Service Bulletin

Bulletin No.: PIC5757

Subject: Blower Motor Inoperative and/or Water In Blower Motor Control Module Area DTC

Models: 2013 Chevrolet Malibu eAssist

2919855

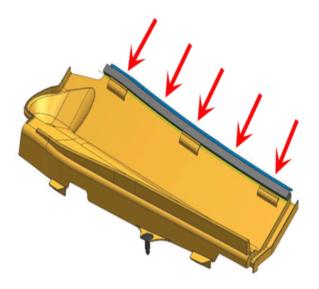
If this concern is duplicated inspect the blower motor, blower motor control module and connectors for signs of water. If water is found it will be necessary to reseal the plenum deflector (see images below) and then replace parts and repair connectors as needed. Remove the air inlet grille to access the plenum water deflector.

Remove the plenum water deflector and add a closed cell foam strip (1/4" tall x 3/8" wide acquired locally) across the entire top of the deflector. Reinstall water deflector and air inlet grille.
